RE: London Borrow Pit, File No., M-2024-016
110c Construction Materials Limited Impact Application, Adequacy Response

MineWater LLC submits this response to your June 12, 2024 adequacy review for the London Borrow Pit. Each item from that letter is addressed directly below, with additional documents attached as needed.

Figure 1. Google Earth Oblique View from 2011, following landslide.

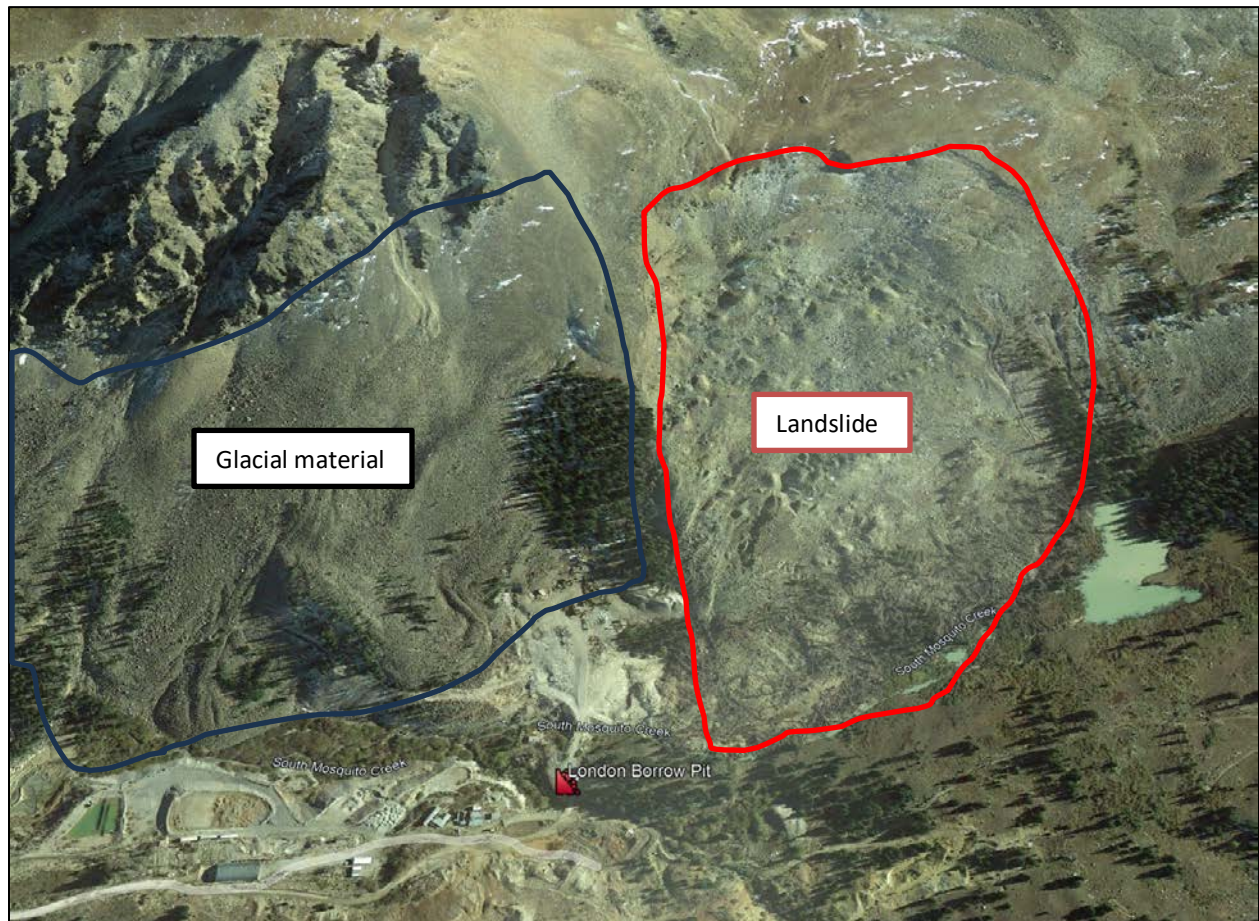
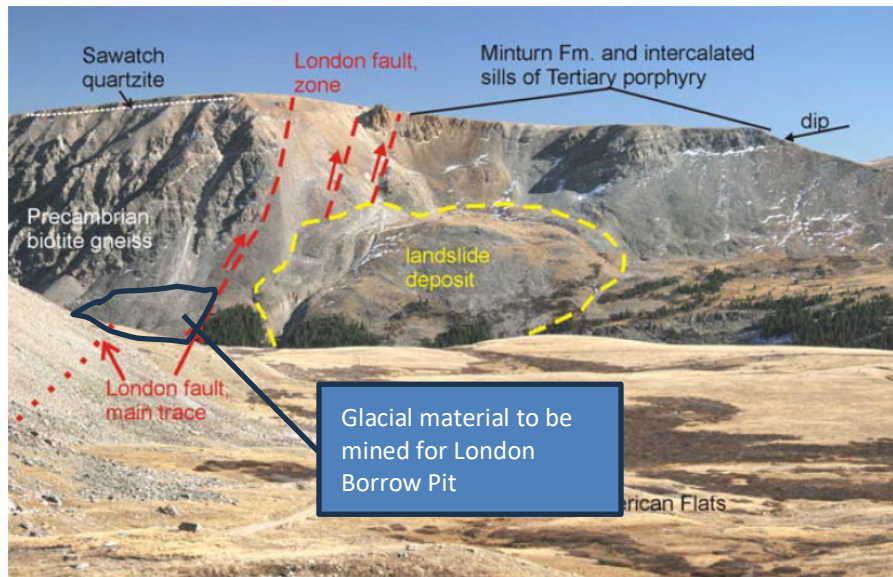
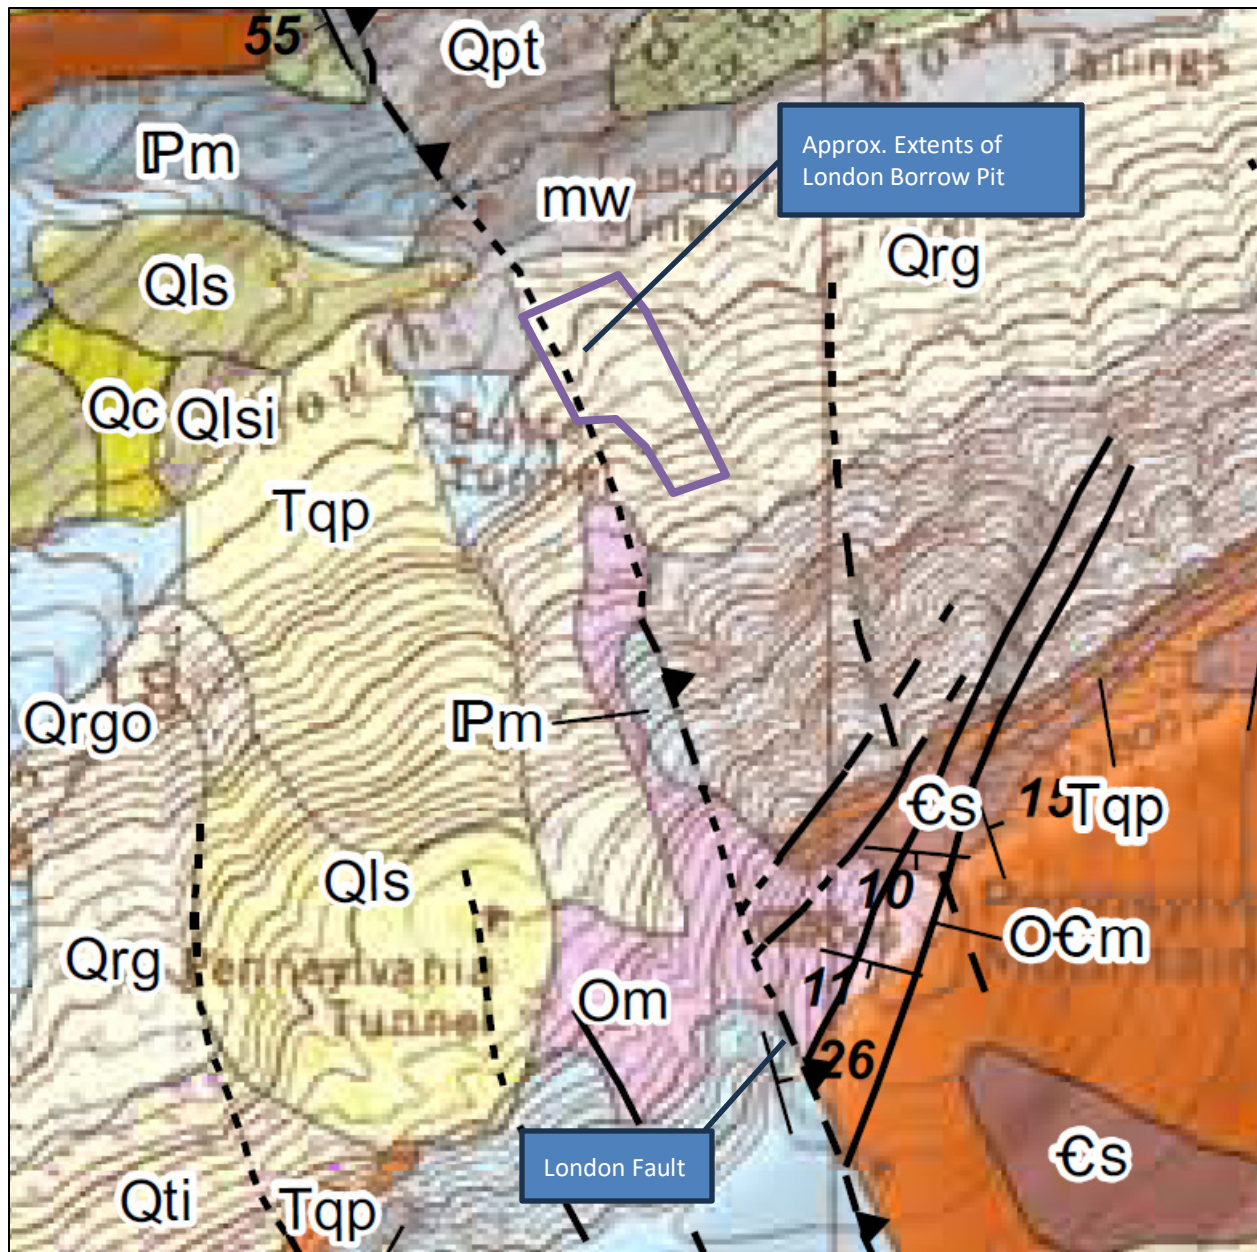
13. *The Geotechnical Stability Analysis states there are no known geological hazards on the proposed site. Please revise this exhibit to discuss the substantial landslide which has occurred immediately west of the proposed site. Please provide any known details on the date and known/speculated causes of the landslide.*

The landslide is distinctly west of the site, outside of the affected area. Discussion regarding the landslide has been added to the Geotechnical Stability Exhibit.

There are no known geologic hazards within the affected area itself. Roughly 170 feet to the west is the remanent of a landslide that occurred in 2011. The landslide material is west of the London Fault while the material being mined by the London Borrow Pit is east of the fault. According to US Geological Survey reports, the material west of the of the fault is predominantly Minturn Formation, which is weaker than the Precambrian rocks east of the fault. Landslides in Precambrian rocks are rare unless shearing, faulting, or alteration has induced low rock mass strength. Figure 1 and Figure 2 both show how the different materials sit on the two sides of the London Fault. The glacial deposit and landslide deposit can be clearly differentiated visually, with the glacial deposit spread in the expected fan shape over the underlying bedrock. The landslide deposit shows a clear scarp at the top of its failure.

The cause of the landslide is not known to the applicant or Lewicki & Associates. However, given the weaker and more landslide prone type of rock east of the London Fault, it is likely that simple weathering led to the landslide.
